SWA10A-700

1 WIRE CLAMP

| Entered: Date:   |                                       |   | OADT                   |  |  |  |
|--|---------------------------------------|---|------------------------|--|--|--|
|  | WORK ORDER NON-CONI                   | FORMANCE / ROUTE UPDATE   | DAR                    |  |  |  |

| N A-A                    |                    |              |     |  |                          |     |  |  |  |
|--------------------------|--------------------|--------------|-----|--|--------------------------|-----|--|--|--|
| DWG NO.                  | DWG NO. SWA10A-700 |              |     |  |                          |     |  |  |  |

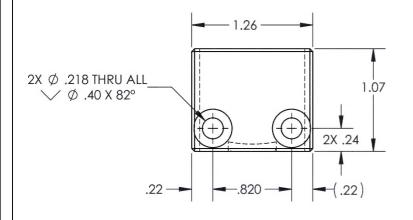
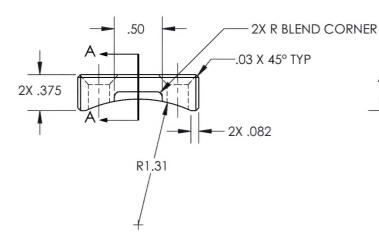
## SEE ATTACHED DEVIATION

| Entered: Date:   |                                       |   | OADT                   |  |  |  |
|--|---------------------------------------|---|------------------------|--|--|--|
| When assembling a SWA10A-3 it w                                    | as noticed that the clamping          |   | Completed by           |  |  |  |
| compression of the SWA10A-700 o                                    | onto the 3 conductor is not adequate. | This deviation is acceptable.   |                        |  |  |  |
| A modified / custom SWA10A-700 was used in place of the standard S | with a clamping thickness of 0.175"   | The clamping force has been visually verified by A. Patry & M. Lee. 3 MBB | Lead hand / Supervisor |  |  |  |

| Entered: Date:   |                                       |   | OADT                   |  |  |  |
|--|---------------------------------------|---|------------------------|--|--|--|
|  |                                       | The fit, form, and function of the part will be as originally intended.   |                        |  |  |  |
